Point Beach Nuclear Plant, Units 1 and 2
Dockets 50-266 and 50-301
Renewed License Nos. DPR-24 and DPR-27

License Amendment Request 241
Alternative Source Term
Response to Request for Additional Information

LICENSE AMENDMENT REQUEST 241 ALTERNATIVE SOURCE TERM RESPONSE TO REQUEST FOR ADDITIONAL INFORMATION

**CONTROL ROOM HVAC PIPING AND
INSTRUMENTATION DIAGRAM (P&ID)**

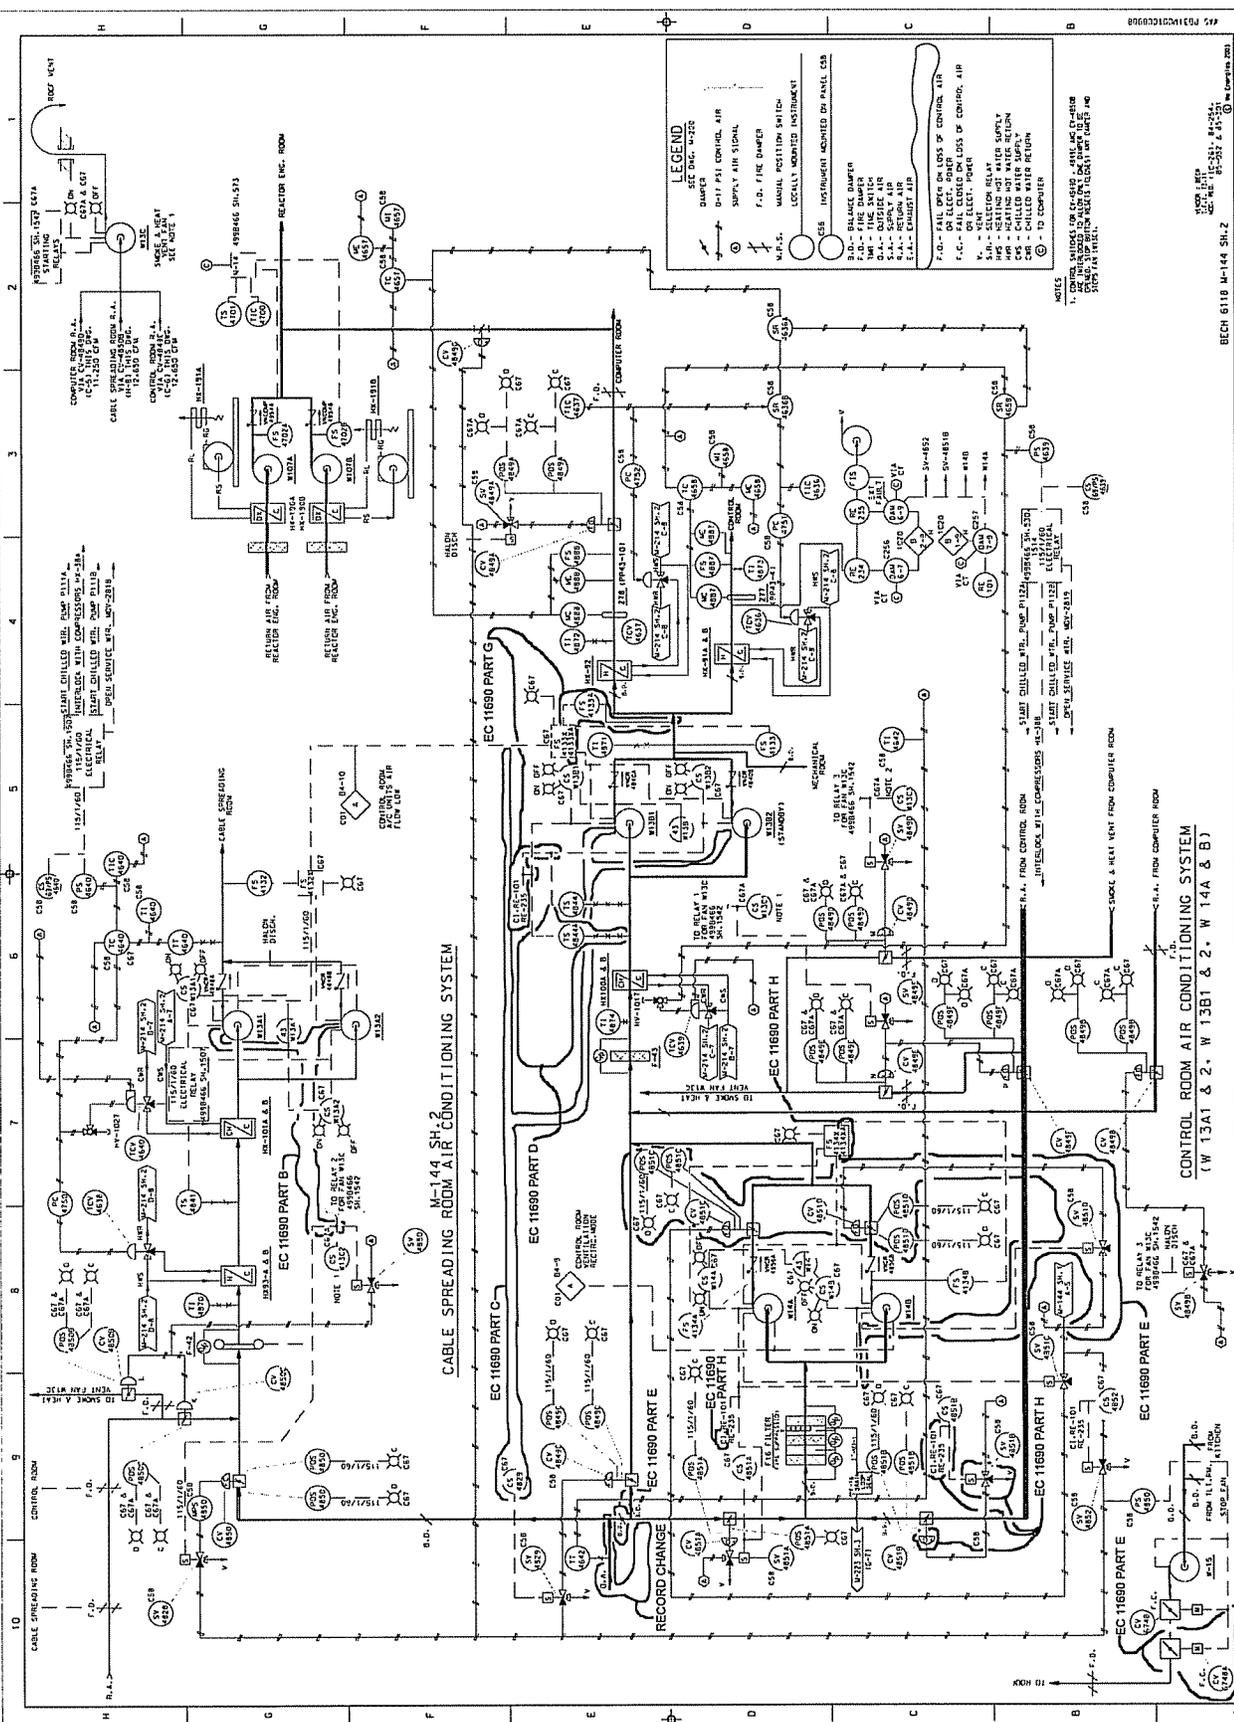
Describe how the CREFS and VNPAB meet the single-failure criterion.

Enclosure 2 contains the control room heating, ventilation, and air conditioning (HVAC) piping and instrument diagram (P&ID). The CREFS portions of this system credited in the AST analysis include:

- Inlet ductwork from outside air and the control room
- Control room charcoal/high efficiency particulate/roughing filter (F-16) and housing
- Control room charcoal filter fans (W-14A/B), discharge dampers, and associated suction and discharge ductwork
- Control/computer room outside/return air filter (F-43) and housing
- Control room recirculation fans (W-13B1/B2), discharge dampers and associated suction and discharge ductwork
- Discharge ductwork to control room envelope areas

Modifications to CREFS in support of the AST LAR ensure that no single active failure of a mechanical component, or single active or passive failure of an electrical or control component, will prevent the system from performing its required function.

With regard to mechanical design, redundant fans are provided. Additionally, for dampers required to change position in shifting from the normal operating mode (Mode 1) to the accident mode (Mode 5), redundant dampers are provided. Dampers not required to change position in shifting from Mode 1 to Mode 5 fail in their required positions, and thus, do not require redundancy.

For electrical power supplies, redundancy is provided as follows:

- Control room recirculation fan W-13B1 is powered from safety-related Class 1E, safeguards 480 V MCC 2B-32. Power to 2B-32 is supplied from 4.16 kV bus 2A-05, which is supplied from Train A emergency on-site power.
- Control room recirculation fan W-13B2 is powered from safety-related Class 1E, safeguards 480 V MCC 1B-42. Power to 1B-42 is supplied from 4.16 kV bus 1A-06, which is supplied from Train B emergency on-site power.
- Control room charcoal filter fan W-14A is powered from safety-related Class 1E, safeguards 480 V MCC 1B-32. Power to 1B-32 is supplied from 4.16 kV bus 1A-05, which is supplied from Train A emergency on-site power.

- Control room charcoal filter fan W-14B is powered from safety-related Class 1E, safeguards 480 V MCC 2B-42. Power to 2B-42 is supplied from 4.16 kV bus 2A-06, which is supplied from Train B emergency on-site power.

Redundancy in controls is provided as follows:

- A separate flow switch and relay is provided for each control room recirculation fan.
- A separate temperature switch and relay is provided for each control room recirculation fan.
- Each control room recirculation fan circuit has a relay which prevents start of the other fan.
- A separate time delay relay and control relay is provided for each control room charcoal filter fan.
- Each control room charcoal filter fan circuit has a relay which prevents start of the other fan.
